ADDENDUM NO. 2

August 25, 2023

**North Central High School Outdoor Athletic Facilities - Phase 4b –Main Package
1801 East 86th Street
Indianapolis, IN 46240**

TF005.4

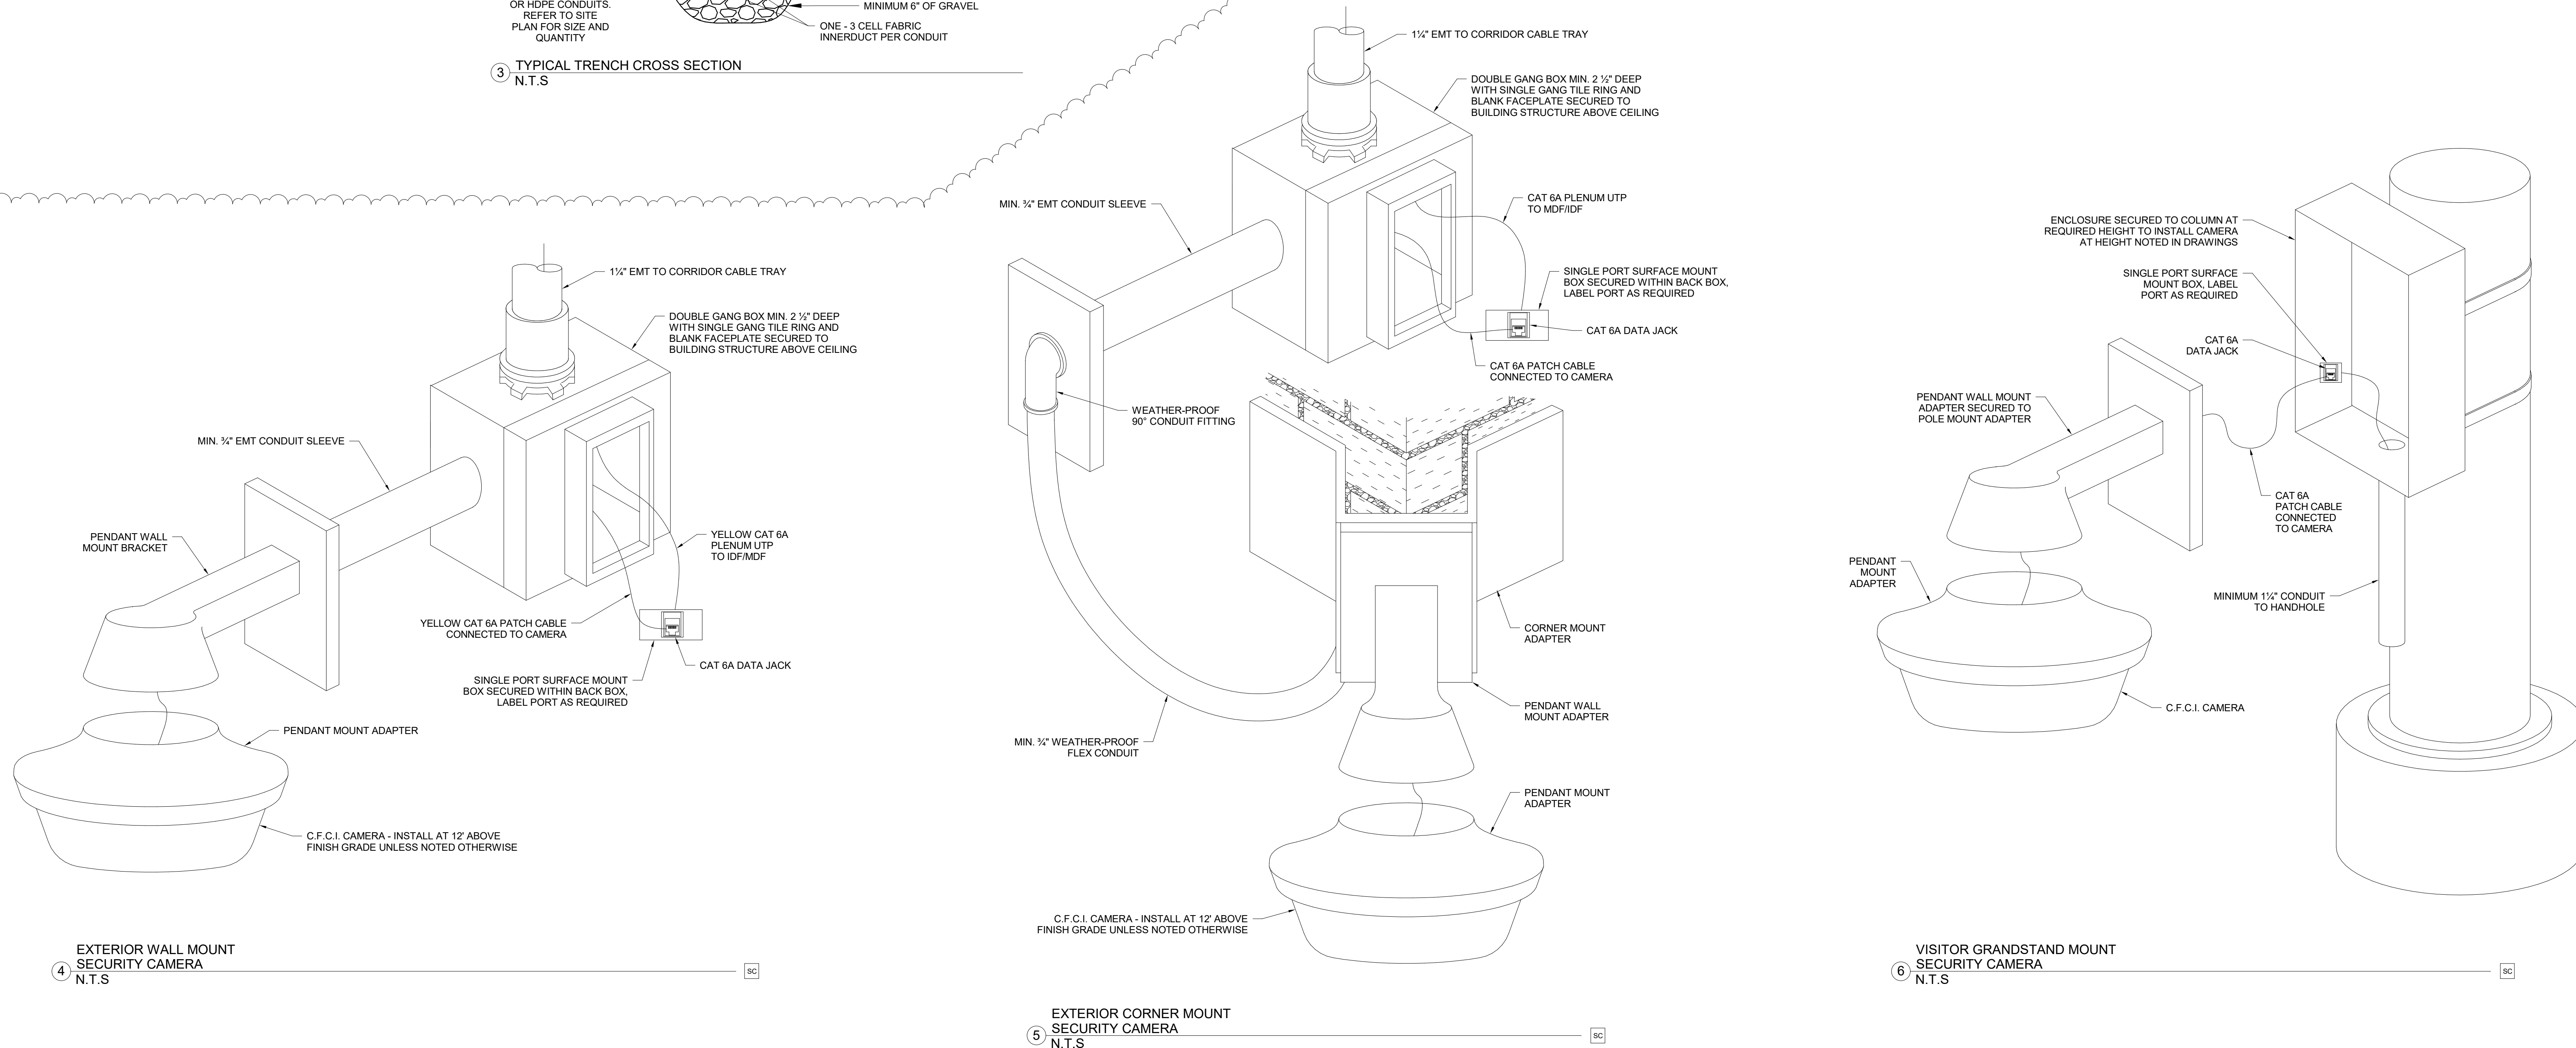
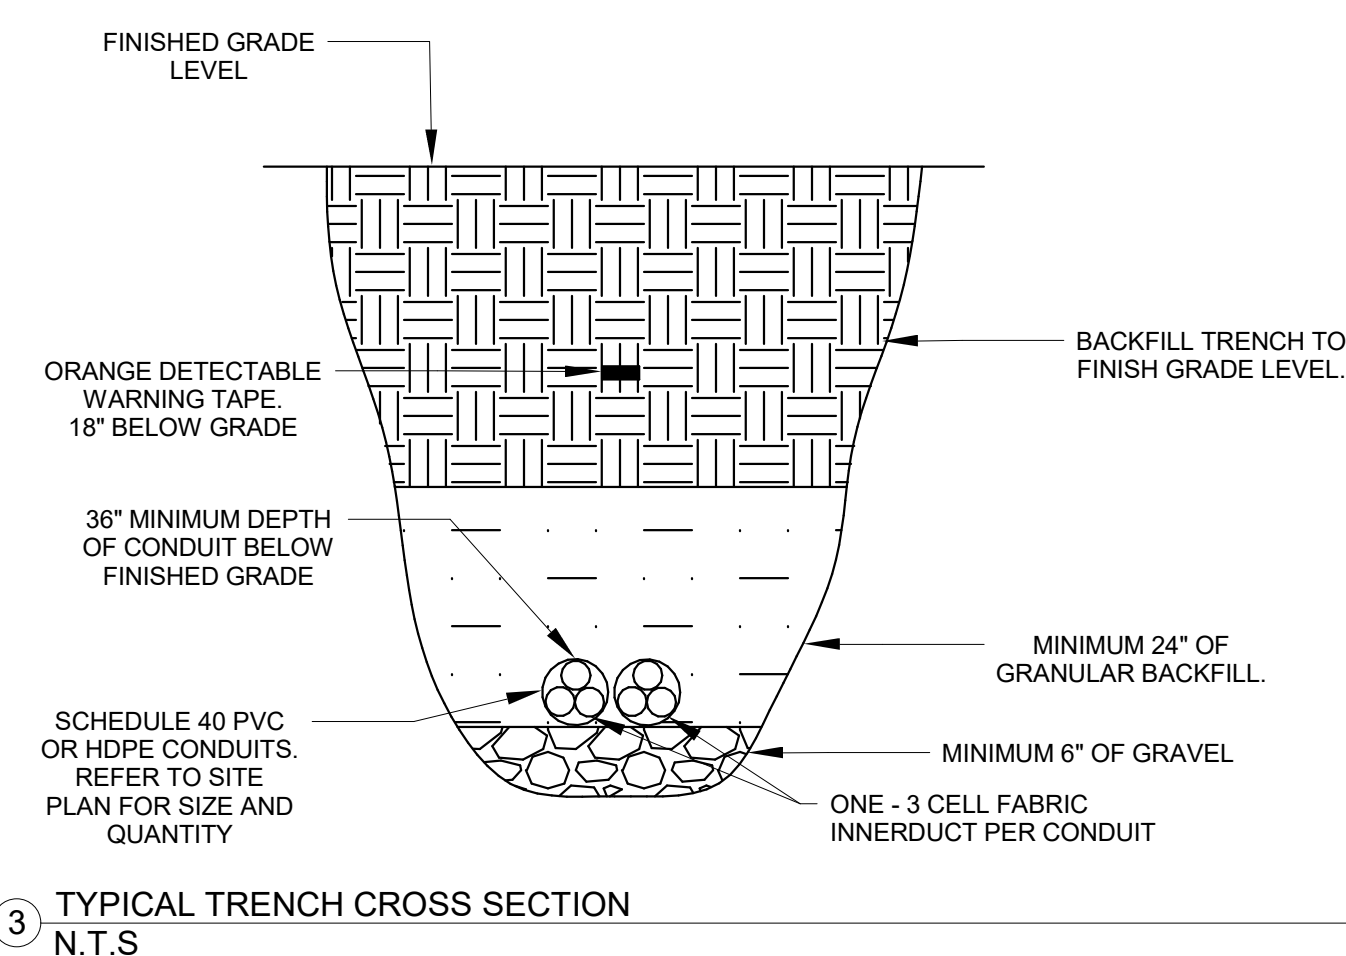
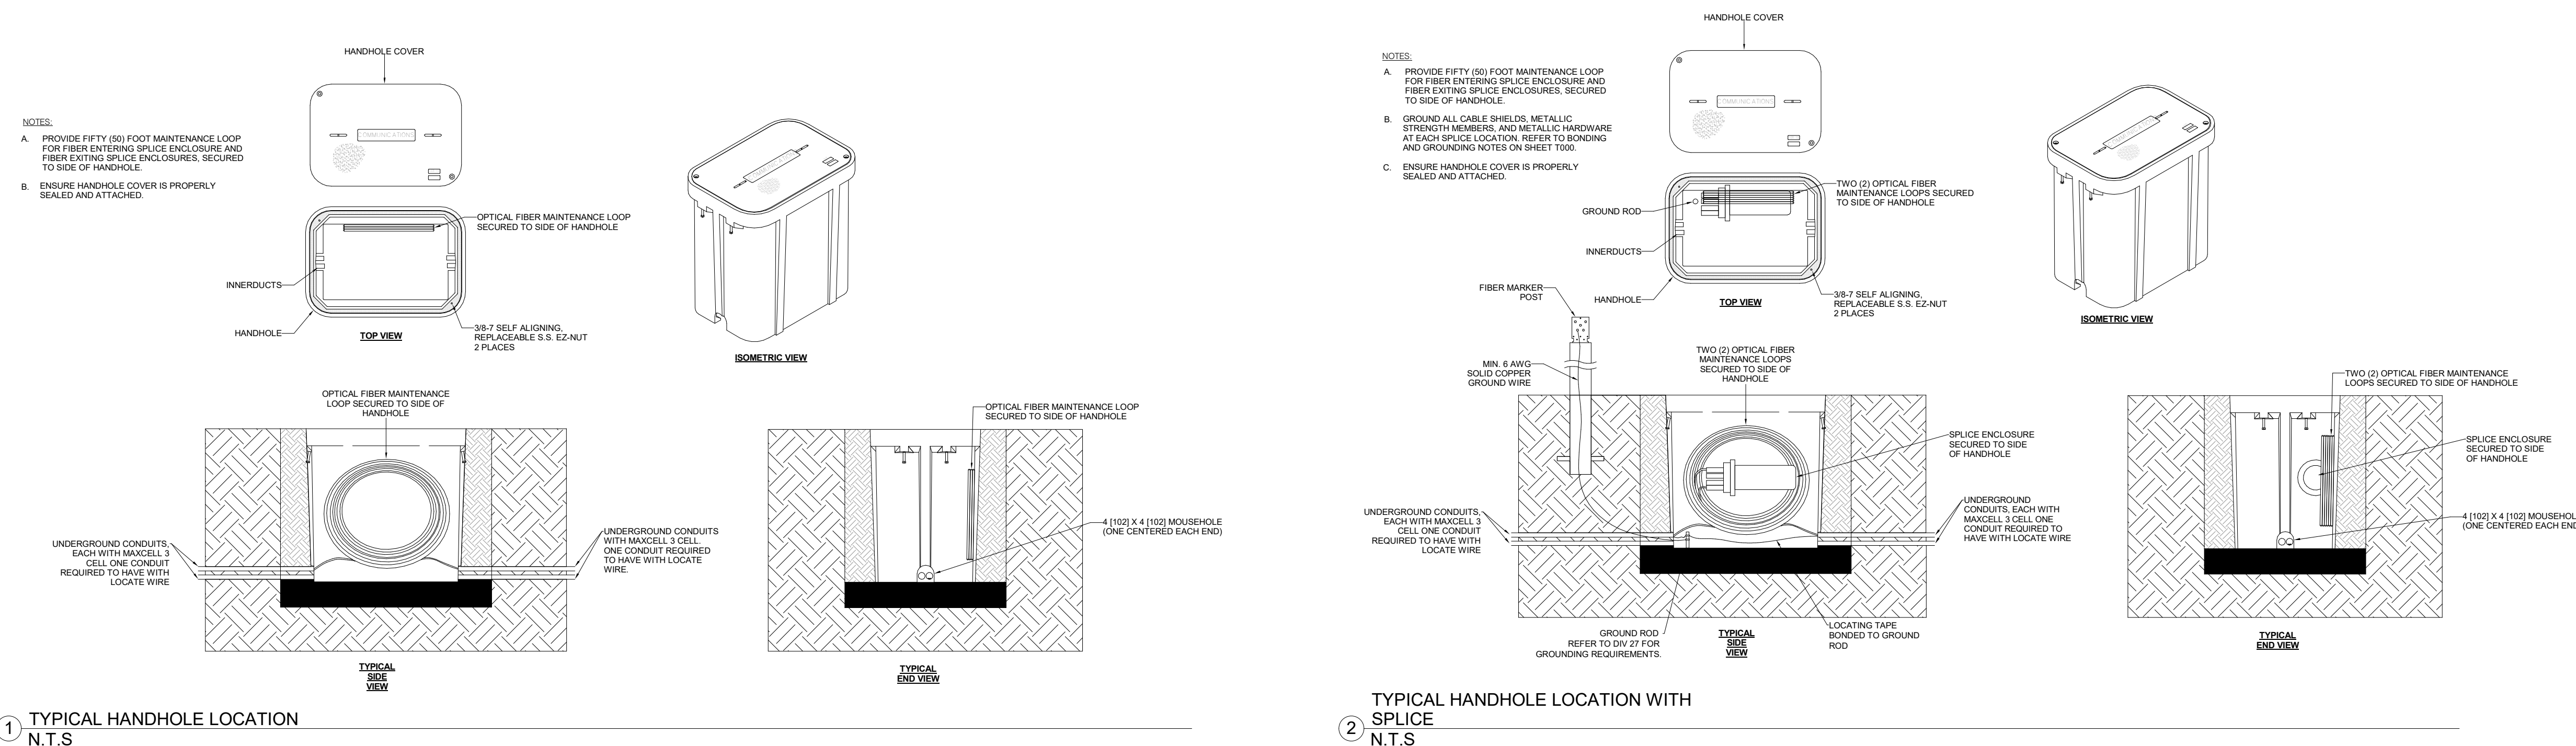
2. On sheet 2/TF004, note 13 says to put a 6 strand MM cable in from JEL to splice point in new handhole and then splice (4) 6 strand MM in the handhole. The cabling from JEL to handhole would have to be a 24 strand MM. Please clarify.

- a. **Answer: 6 strand MM to JEL to remain. All other new 6 strand cabling shall be Single-mode in lieu of multi-mode. Contractor shall refer to updated riser diagram included in Addendum #2 for clarification.**

MAIN
PRESSBOX/CONCESSION
TECHNOLOGY FLOOR
PLAN
F-TF201.4

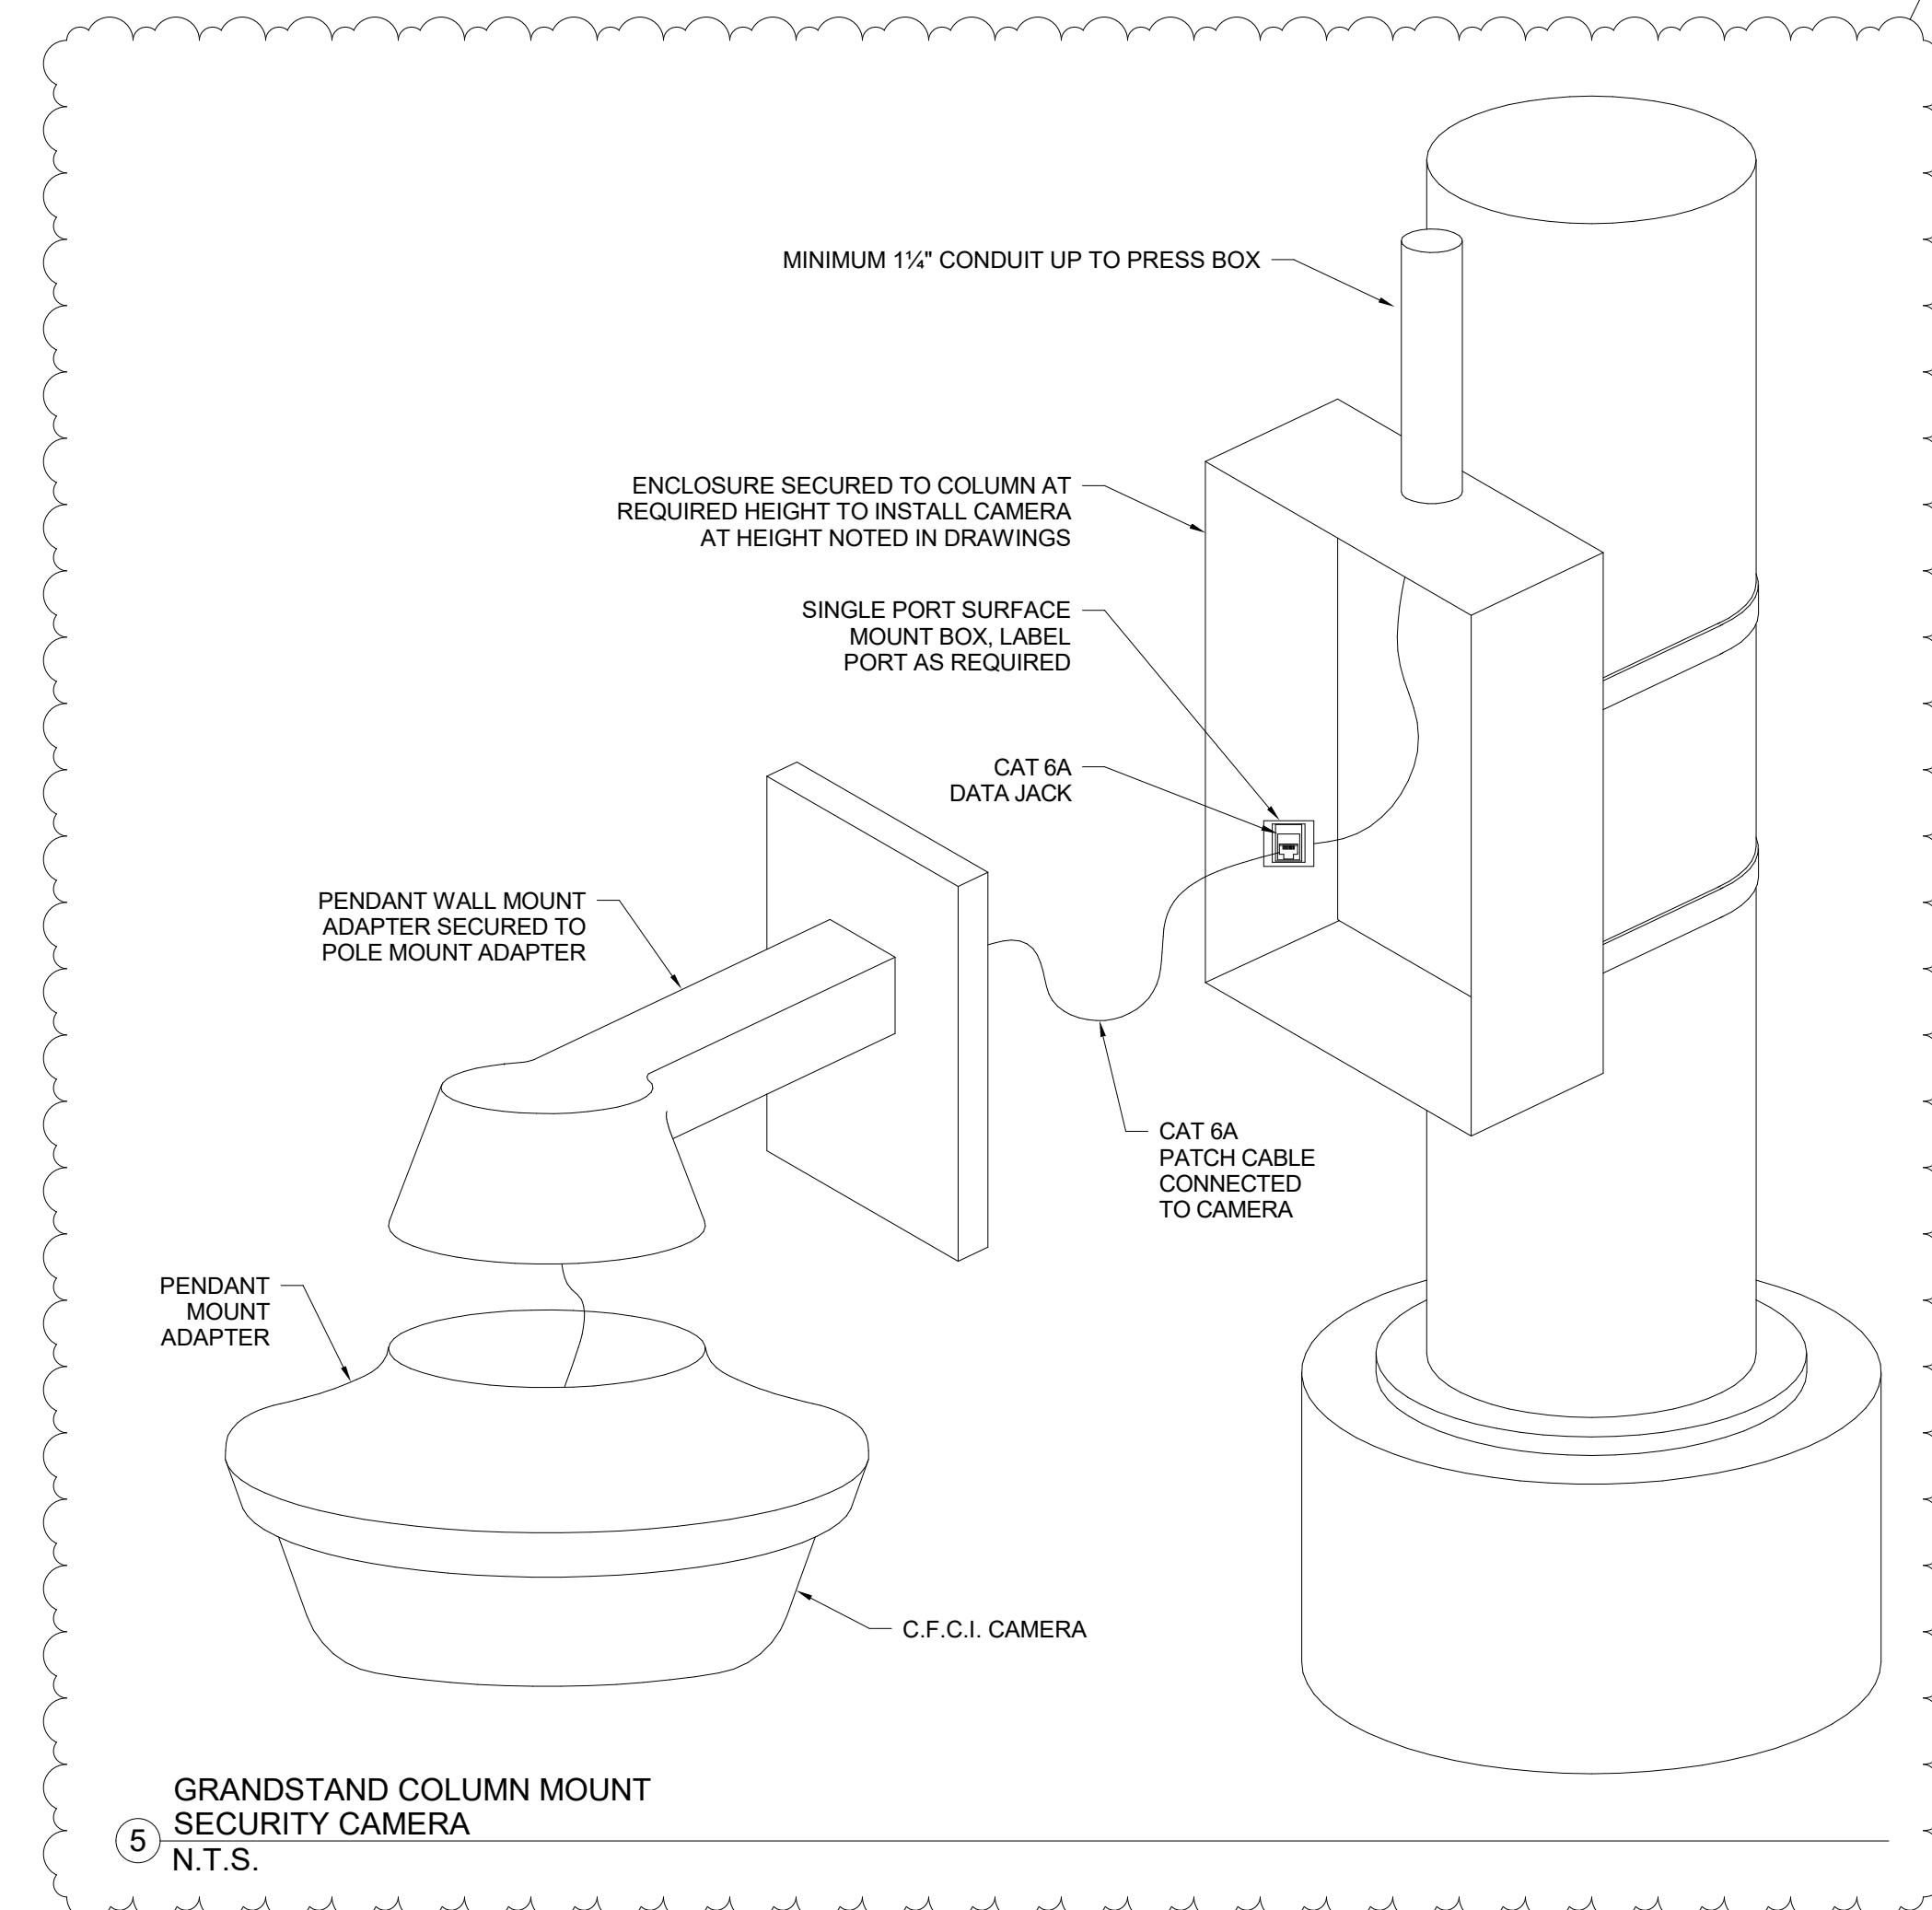
6. On drawing TF-201.4, Main Press Box Concession, camera 08-A-32, camera is on Telecom Schedule, but not on the drawing.
 - a. **Answer: labeling information for this camera location has been clarified in Addendum #2 documentation.**
